**Drainage Submission in support of
Planning Application No: A/YL-TYST/1293
for a Proposed Warehouse Development at
Lots 1198sC (Part) and 1198sF (Part) in DD119, Pak Sha Tsuen,
Yuen Long, New Territories**
(Rev. 1)

Responses to Comments from Government Departments on Planning Application No. A/YL-TYST/1293 (refer to Planning Department's email of 23 January, 2025)

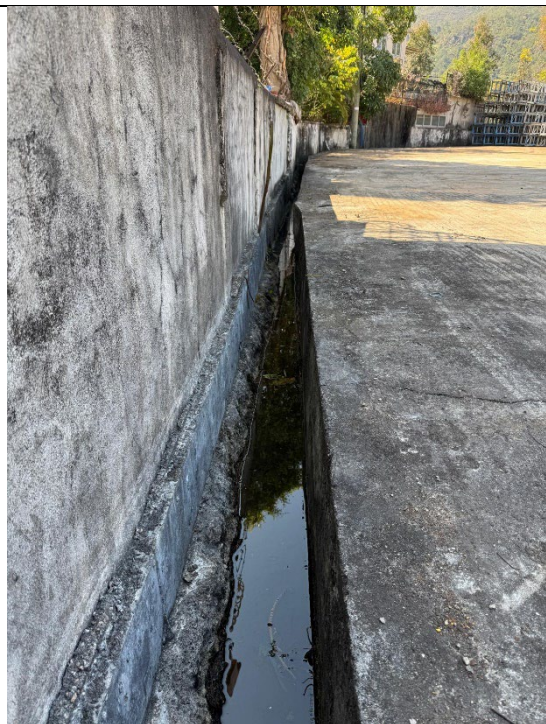
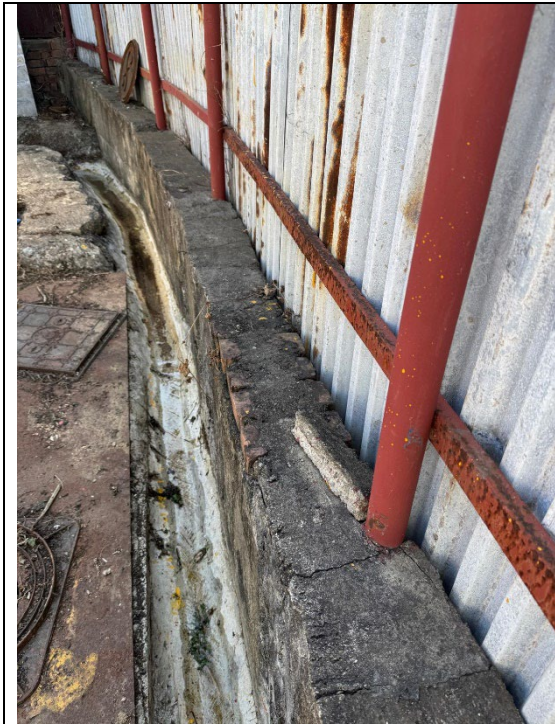
COMMENTS	RESPONSES
CE/Mainland North, Drainage Services Department (DSD)	Applicant
Subject to no site formation works/levelling works to be carried out and no hoarding/walls to be erected under this planning application, I have no comments on the submitted drainage proposal. However, according to the photos provided in the submitted drainage proposal (Photos 3, 4, 5, 6, 8 and 9 refer), sediments were found inside the existing drainage system. Please ask the applicant to clear the existing drainage systems and provide updated photos for review.	Sediments inside the existing drainage system have been cleared. Updated Photos 3, 4, 5, 6, 8 and 9 are replaced and used in the revised report.
